**GOVERNMENT OF THE DISTRICT OF COLUMBIA
DEPARTMENT OF TRANSPORTATION**

MEMORANDUM

SUBJECT: Large Tract Review Case No. 18-01 – 1515 New York Avenue NE (Hecht East)

Figure 1 – Site Design and Access (Source: Applicant)

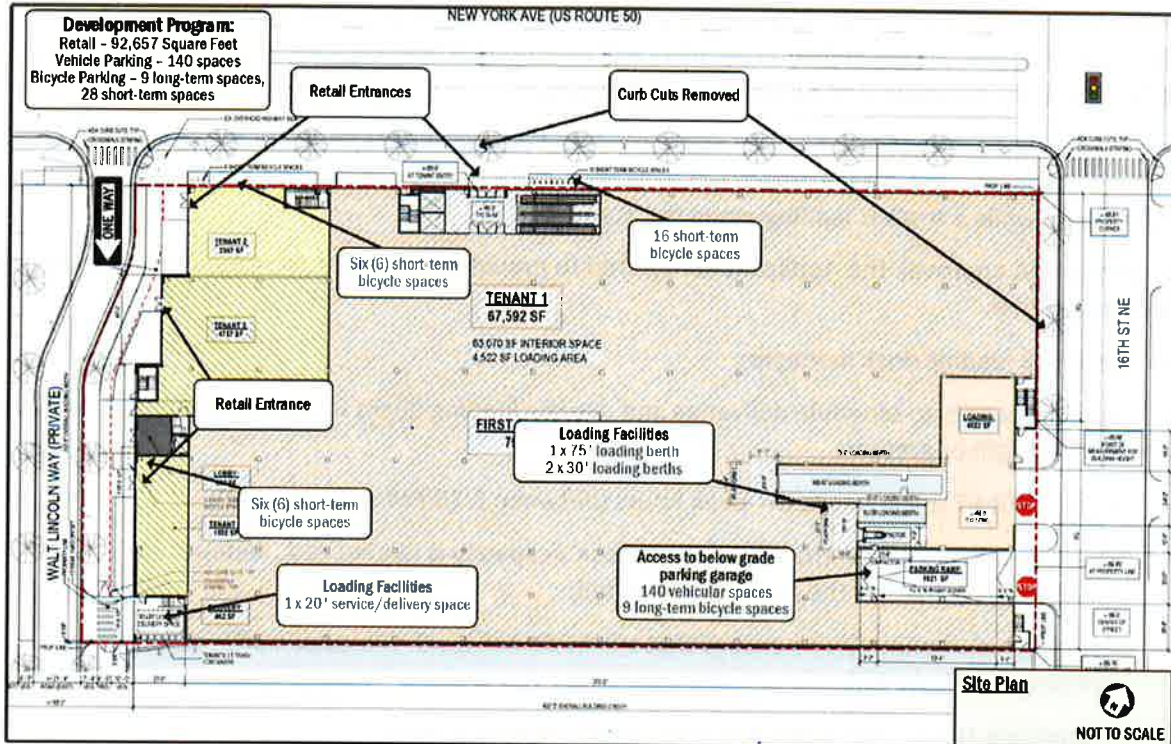
Access to the 140-space below-grade parking garage and on-site loading facilities for the large-format retailer is proposed via two curb cuts on 16th Street NE. Secondary loading for the small format retailers is proposed along Walt Lincoln Way, a private street to the west of the site.

Pedestrian access for the large format retailer is proposed from New York Avenue. The small format retail will have front pedestrian entrances from Walt Lincoln Way. Access to the long-term bicycle parking spaces is from the garage curb cut on 16th Street.

Loading for the large format retailer is proposed via a loading dock on 16th Street NE. The loading dock contains one (1) 75-foot loading bay and two (2) 30-foot loading bays. The larger loading bay exceeds the berth size required by zoning but was determined to be necessary to accommodate the loading needs of the large format retailer.

DDOT standards stipulate that truck movements for a site should be accommodated without back-in movements through public space. Large (WB-67) trucks will be required to accommodate operations for the large format retailer. DDOT determined that it would not be feasible for the largest trucks (WB-67) to operate without back-in movements. Accordingly, the largest trucks will need to back-in to the loading dock. The Applicant provided truck turning diagrams showing that the truck maneuvers can be accommodated without conflicting with the proposed portion of the New York Avenue trail project that will be designed as a two-way cycletrack on the east side of 16th Street. 30-foot trucks serving the site are expected to operate without back-in movements through public space. The Applicant coordinated closely with DDOT to design the loading facility such that adequate space is provided on private property for head-in/head-out movements.

Loading for the small format retail will be accommodated via the service/delivery space. Loading may also occur along Walt Lincoln Way, which has a 20-foot width that is sufficient to accommodate one way vehicular travel while a truck is loading along the curbside.

Figure 3 Pedestrian Inventory (Source: Applicant's CTR)

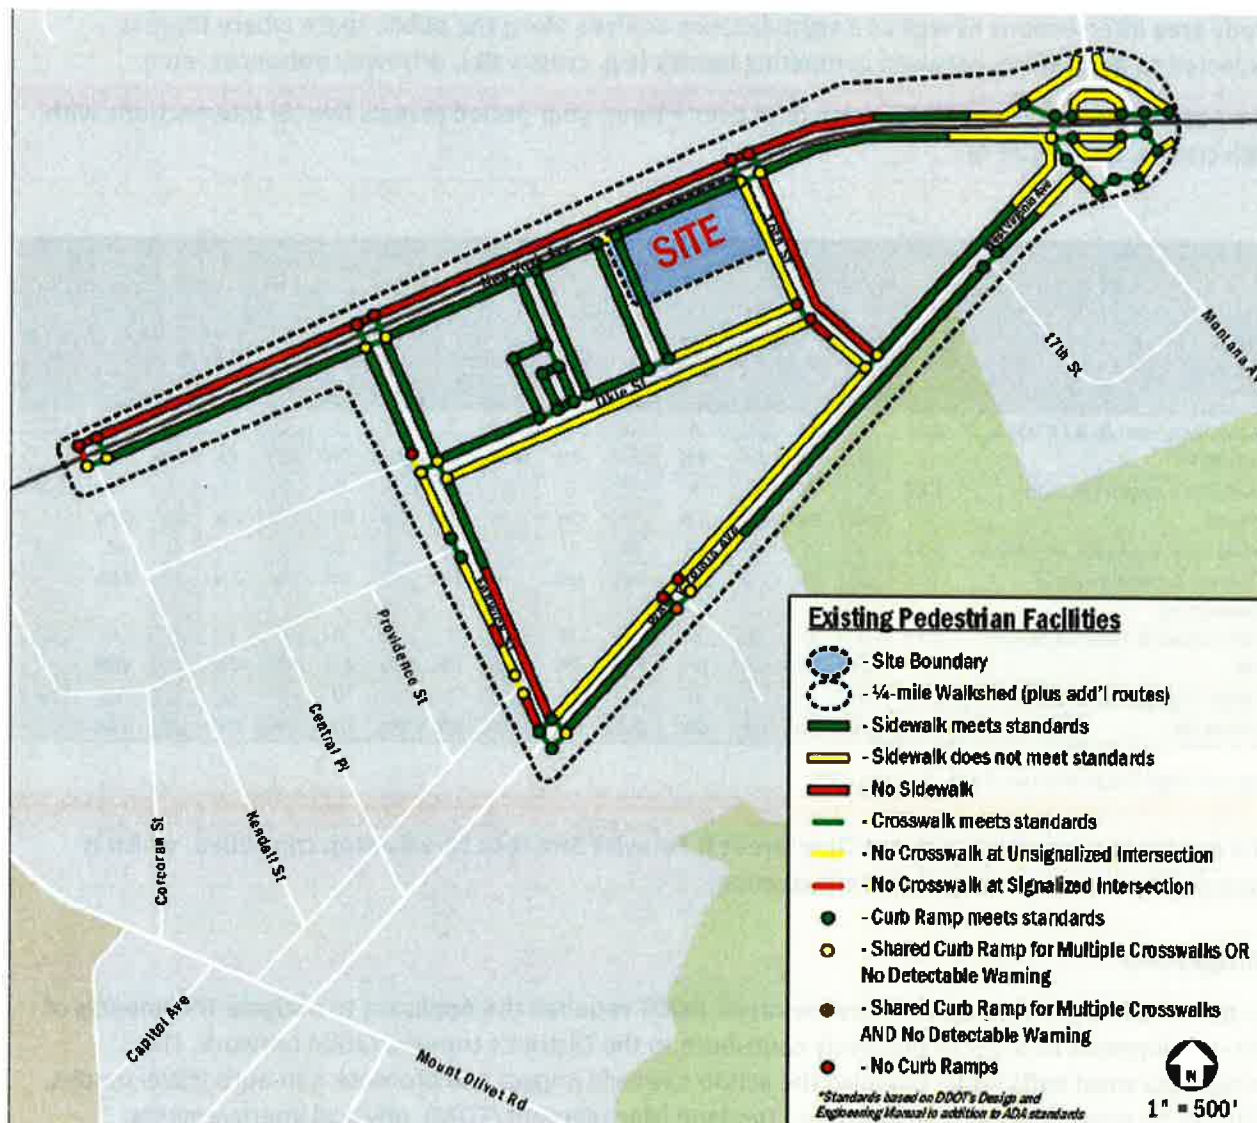
Walk, bike, and transit trips are assumed to comprise 40% of all site trips, equating to 63 trips during the AM peak, 252 trips during the PM peak, and 296 trips. Based on the Applicant's field observations and inventory of the pedestrian and bicycle facilities (i.e., sidewalks, crosswalks, and bicycle lanes), the study area intersections and roadway network do not provide adequate pedestrian connections to nearby land uses and transit facilities. The proposed project is a change in use in a predominantly industrial area that will create new pedestrian trips and demand. The proposed project that cannot be accommodated under the existing infrastructure. As shown in Figure 3, various sidewalks and curb ramps are completely missing or do not meet current standards. Of note, the Applicant provided analysis that incorporates future sidewalk improvements by other nearby developments and DDOT projects, including DDOT's New York Avenue NE Streetscape and Trail project. While this project is planned, it is not currently funded and therefore the pedestrian improvements associated with that project should not be assumed to be completed prior to the opening of the subject development. Also worth noting is that an ADA connection between the site and the bus stop has been implemented and is not reflected in Figure 3, thus providing an ADA-compliant connection to the bus stop.

Based on the Applicant's analysis, pedestrians arriving from north and east of the site from the nearby neighborhoods do not have a direct path that meets DDOT standards. Without a robust pedestrian network, it is unlikely that the mode split can be reached on the residential component.

As noted above, additional parking is available in the parking garage immediately to the west of the site. Accordingly, an ADA-compliant pedestrian connection between the subject site and the parking garage should be provided. Under existing conditions, ADA-compliant curb ramps are installed but the crossing lacks a marked crosswalk. In addition, curb ramps should be provided along the eastern side of Walt Lincoln Way on both sides of the service/delivery space to connect to the existing sidewalk to the south of the site. The Applicant committed to these improvements as a condition of BZA approval.

Figure 5 New York Avenue Trail and Streetscape Concept Plan for New York Avenue & 16th Street NE (Source: DDOT)

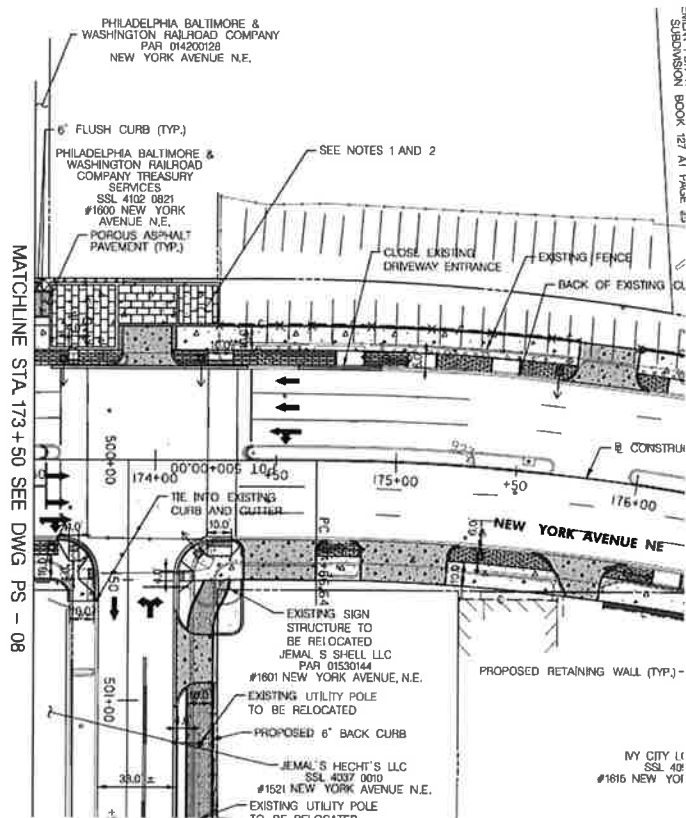
The following improvements to the north side of New York Avenue at 16th Street are needed to improve the pedestrian network in the vicinity of the site:

- Provide a curb ramp at the northwest corner of the New York Avenue & 16th Street intersection. This will require the removal of one (1) street tree and
- Bring the existing driveway on the north side of the intersection up to current DDOT standards. This includes narrowing the driveway and redesigning it as a street cut with curb, gutter, and curb ramps. Design of the driveway should be consistent with DDOT’s New York Avenue Trail and Streetscape Project (Figure 5).
